Editors, suggest adding as the last subclause in section 100.2.9

100.2.9.7 CNU RF transmitter time reporting requirements

Figure 100-1—Details of RF power amplifier turn on and turn off timing

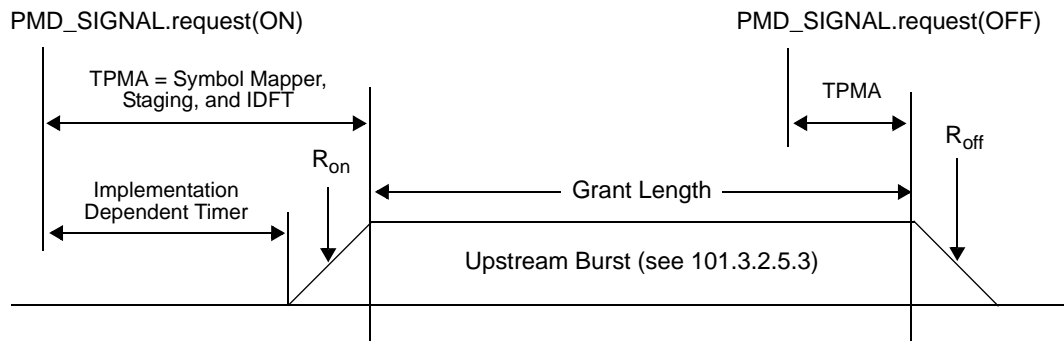
In EPoC, the upstream CNU PMD RF power amplifier (PA) may be turned off between bursts as shown in Figure 100-1X. PMD_SIGNAL.request(ON) is asserted when the first bit of the burst is conveyed from the PCS to the PMA via PMA_UNITDATA.request() (see 101.4.1.2.1). The delay time through the EPoC PMA (TPMA) is no less than the sum of the *RBframe* size multiplied by the OFDM symbol time (*RBsize* of 8 times or 16 times 20 μsec, see 100.2.9.1) plus the implementation specific processing time of the IDFT (nominal range 10 μsec to 40 μsec). For any given implementation and US Profile configuration, TPMA is fixed and the CNU is required to meet the PMD delay variance requirements in 100.2.1.1. The time to turn on and stabilize the PA for meeting burst transmission fidelity requirements (see 100.2.9.2) is represented by R_{on} . The time from PMD_SIGNAL.request(ON) to initiate PA turn on is implementation specific. PMD_SIGNAL.request(OFF) is asserted when the last bit of the burst is conveyed from the PCS to the PMA. PA turn off is initiated after the TPMA delay and after the last OFDM symbol of the burst. The time for the PA to turn off is represented by R_{off} .

The RF transmission of burst energy begins at the beginning of the grant after R_{on} . The R_{on} time period of one CNU may overlap completely with the R_{off} time period of another CNU. Turning the PA off achieves two purposes: meeting the energy efficiency requirements of 100.5 and to minimize the cumulative impact on CLT receiver SNR by avoiding all CNU PAs powered on 100% of the time.

R_{on} and R_{off} times are not included in burst overhead calculations (see 103.x.x.x). TPMA in either *RBsize* configuration is longer than R_{on} maximum (see Table 100-1) and does not impact adjusting grant lead time (see 103.x.x.x).
